**PLANNING COMMISSION MEETING**  
**LOCATION: 7527 HIGHLAND ROAD, WHITE LAKE, MI 48383**  
**(FORMER WHITE LAKE LIBRARY)**  
**THURSDAY, DECEMBER 02, 2021 – 7:00 PM**

**RE: Four Corners Outlot- Preliminary Site Plan, Final Site Plan/Final Engineering Plan Review – 2<sup>nd</sup> Review**

**RE:** Four Corners Square – Retail Center #2  
Preliminary and Final Site Plan – Review #2

White Lake Township,  
Oakland County, Michigan  
**CONSTRUCTION/SITE PLAN DOCUMENTS**  
Prepared For  
**4 Corners Square LLC**  
PART OF THE SE 1/4 OF SECTION 36,  
WHITE LAKE TOWNSHIP,  
OAKLAND COUNTY, MICHIGAN

SHEET  
 Paving & Grading Plan

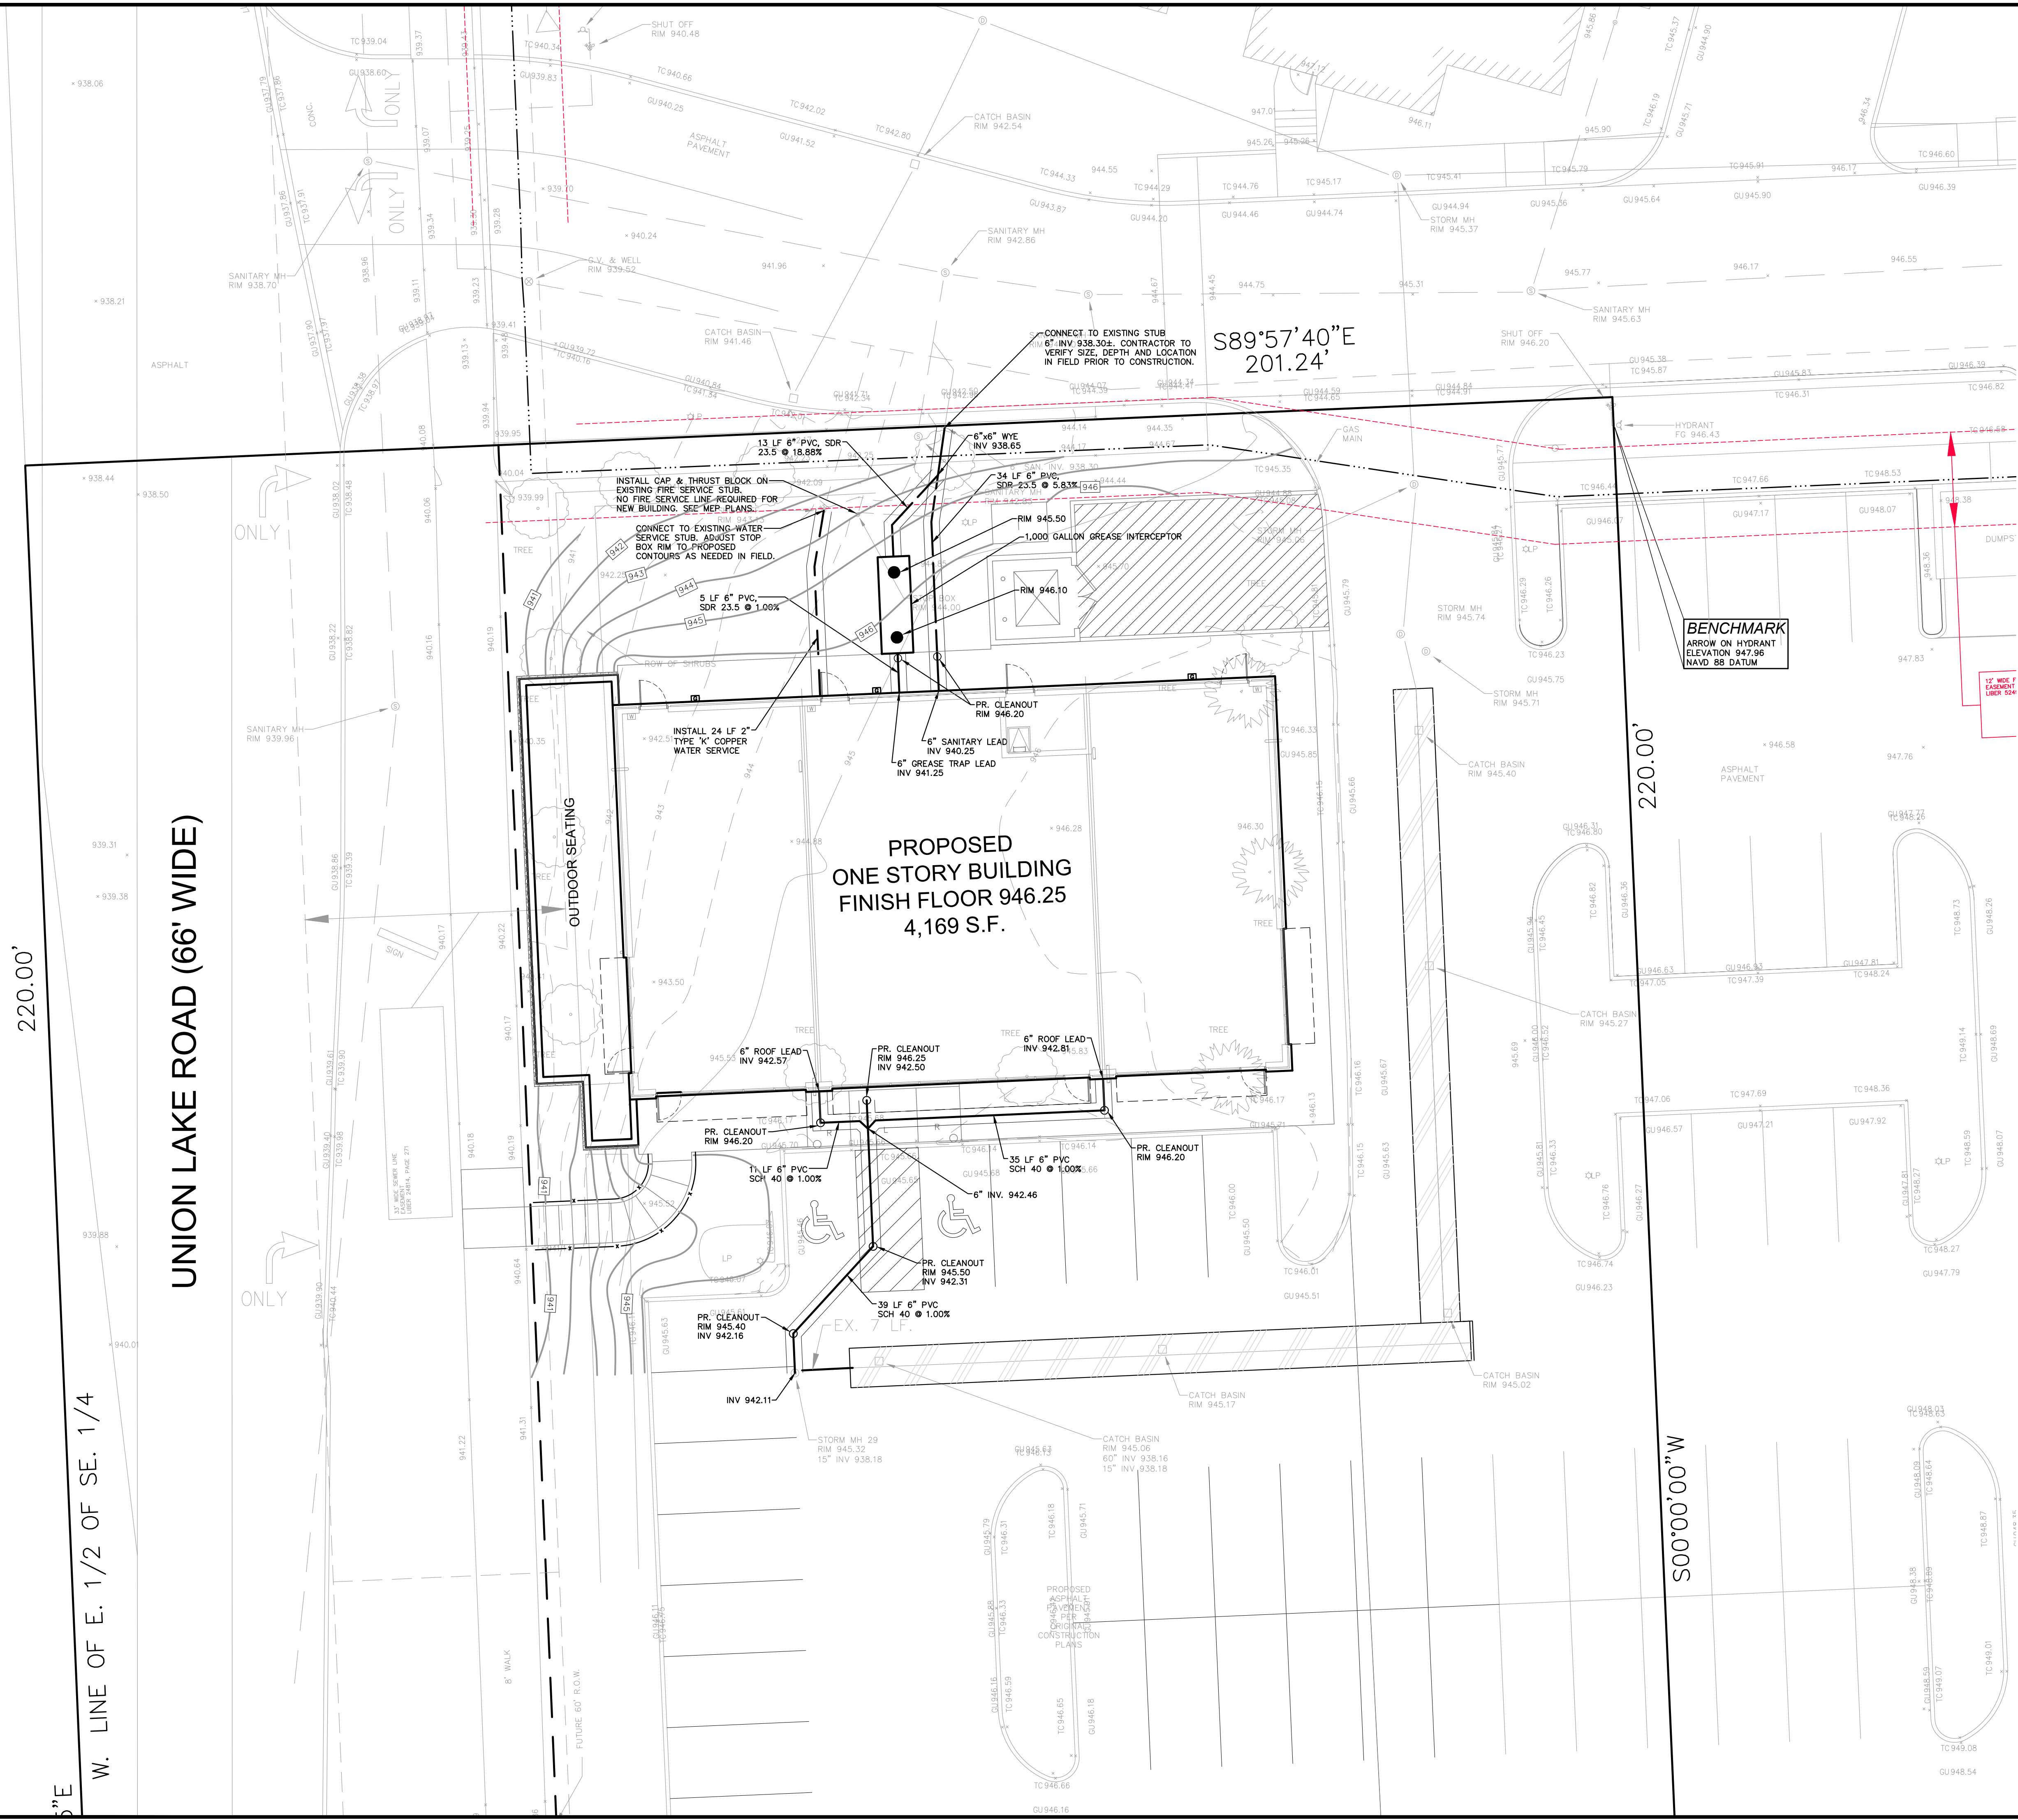
1. *The topo survey shows existing asphalt pavement south of the proposed retail building; however, this pavement does not exist. The curbs have been poured but the pavement has not been placed, please update plans accordingly. **Comment addressed. Design engineer has indicated that the area south of proposed building shall be asphalt paved per original construction plans.***

2. *The existing grade of 946.17 shown adjacent to the southeast corner of the proposed building is shown on the as built plan for 4 Corners as 947.17. Please verify and adjust grade(s) as needed. **Comment addressed. Design engineer notes that grade of 947.17 on as built plan for Four Corners Square appears to be in error.***

3. *Clarify the existing grades shown for the area adjacent to the northeast corner of the proposed building. The as built plan for 4 Corners shows what appears to be an existing ramp in this area with associated as built grades. **Comment addressed. The design engineer states that the existing curb grades do not indicate that there is a curb height drop and thus no existing ramp.***

4. *Although a retaining wall is proposed around the outdoor seating area, it appears that the grades at the bottom of the wall to the north will greatly exceed the allowable grade of 33%. We note that the slopes in these areas will be difficult to maintain and request clarification regarding the proposed grading and ground cover in this area to minimize maintenance and to minimize potential soil erosion. **Comment addressed. The landscape plan has been revised and indicates vegetation proposed in these areas that will minimize maintenance and erosion, per the design engineer.***

6. *The plans show stairs with a handrail extending out to the sidewalk along Union Lake Road. Please note the Road Commission for Oakland County may require these items not extend into the public Right-of-Way as shown on the plans. **Comment addressed. Handrail and sidewalk have been pulled back to outside of ROW.***

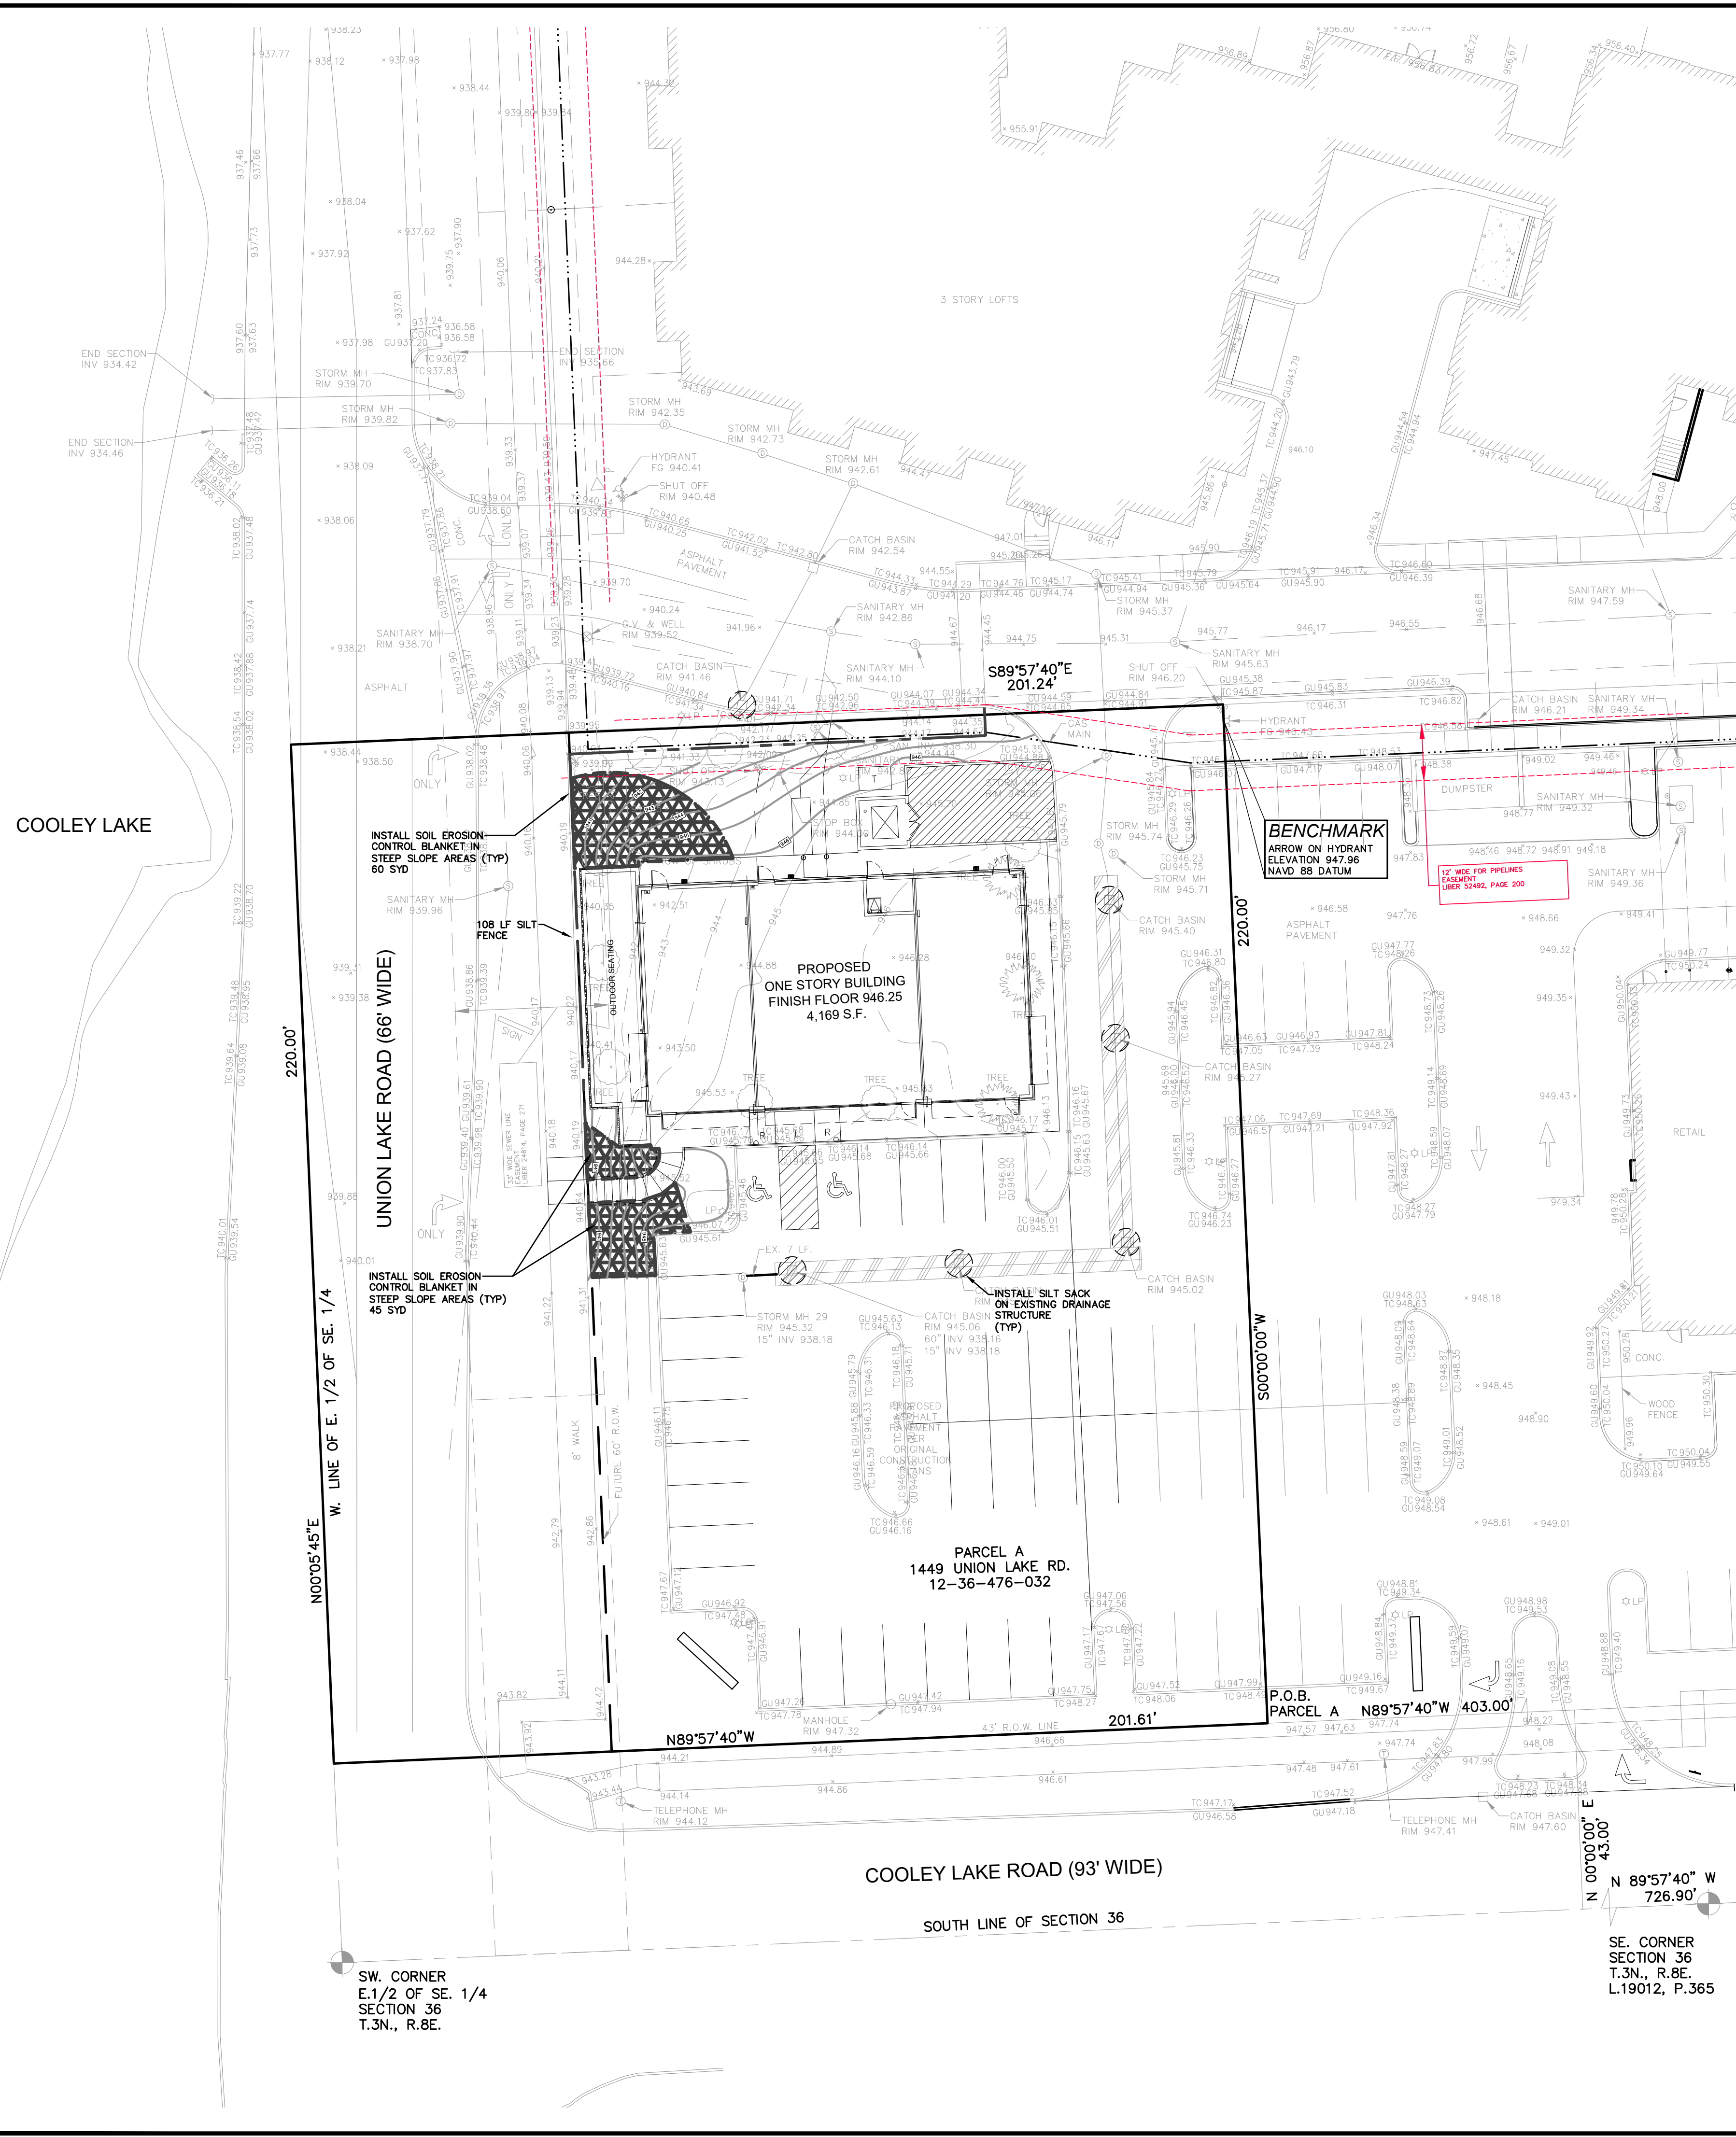
5. *The bollards for the dumpster enclosure shown on Sheet C7 will need to be 6" diameter instead of 4" diameter and also on Sheet A.502 where 5" diameter bollards are proposed. **Comment partially addressed. The bollard diameter is now correct (6") on Sheet C8; note that we did not receive Sheet A.502 as part of this submittal. The diameter of the bollard shall be revised on Sheet A.502 as well.***
